Wall Outlets

Project Name: Webster University-**ISB**

Copies	No.	Description
1 PDF	226313P01	(Submittal No.'s)
		(Cannon #226313-008) - (Paric #15051-0285) – (WES #607)
		➤ Gas Piping Accessories (Vacuum Piping for Lab Facilities)

PROJECT NAME: Webster University ISB
 LOCATION: St. Louis Missouri
 CLIENT PROJ. No.: N/A
 WES PROJ. No.: 607
 226313
 Gas Piping for
 SPEC SECTION: Laboratory Facilities
 SUBMITTAL ITEM:: See Below -

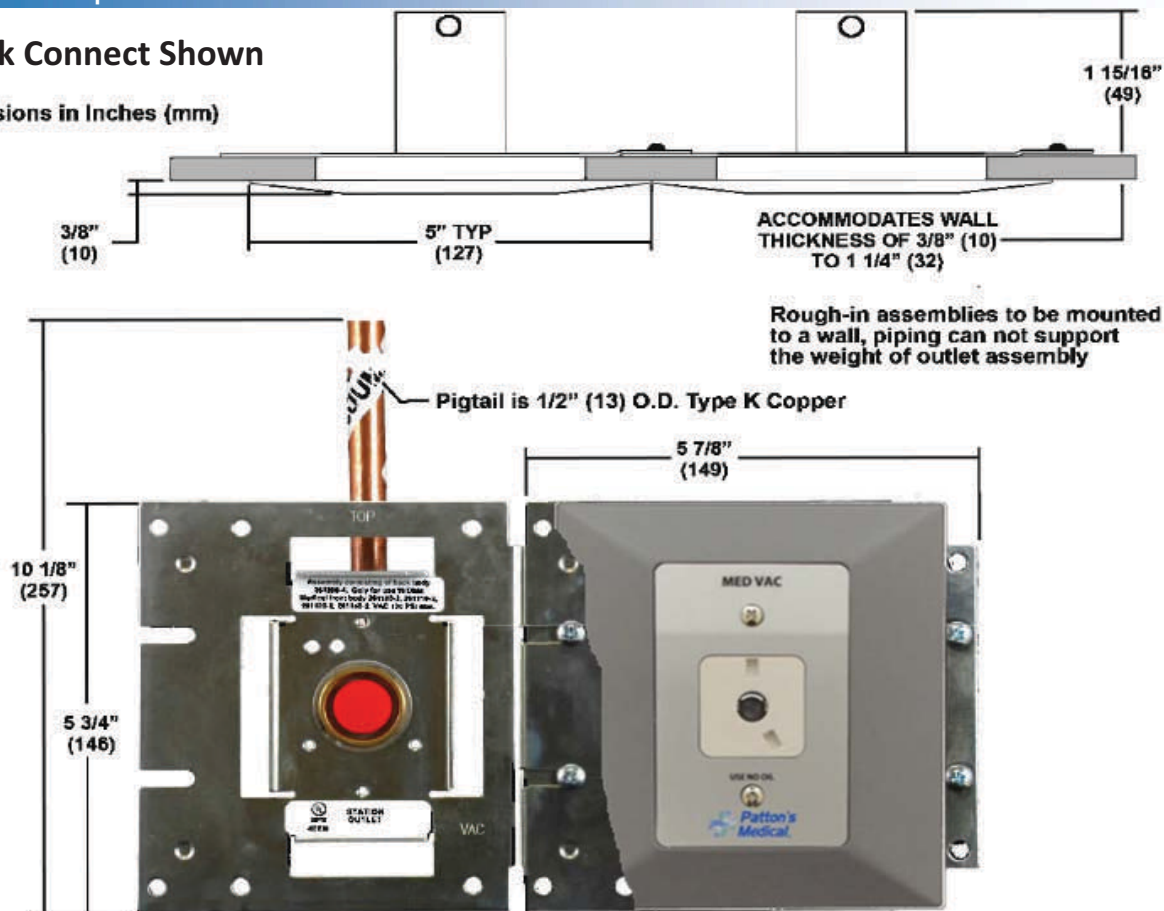
Verify finish of wall plates with Architect prior to ordering.

~~**O1-XXWALM-XXX-X**~~

~~M = M.R.I. Compatible~~

NEC	MCN	AAR	REJ	REV	NO EXCEPTION TAKEN	
					MAKE CORRECTIONS NOTED, NO RESUBMITTAL:	
					AMEND AND RESUBMIT	
					REJECTED, SEE REMARKS:	
					REVIEWED ONLY	
					ITEM	REMARKS
Patton's Medical is not listed in the project manual as an acceptable / alternate manufacturer to the basis of design. Review of their products in this submittal does indicates they are comparable to the basis of design						
X					Zone Valve Box Patton's Medical ZVN 050505050507	
X					Back Mounted Gauges Patton's Medical PM-GA2-300, PM-GA2-100, PM-GA2-VAC	
	X				Wall Outlets and Inlets Patton's Medical D.I.S.S. Type	1. Verify finish of wall plates with Architect prior to ordering.
X					Medical Isolation Valves Patton's Medical 3-Piece Ball Valve	
X					General Purpose Regulator Patton's Medical REG-G-LP-05, REG-G-LP-05	
X					Header Bar Accessories Misc. Fittings and Hardware
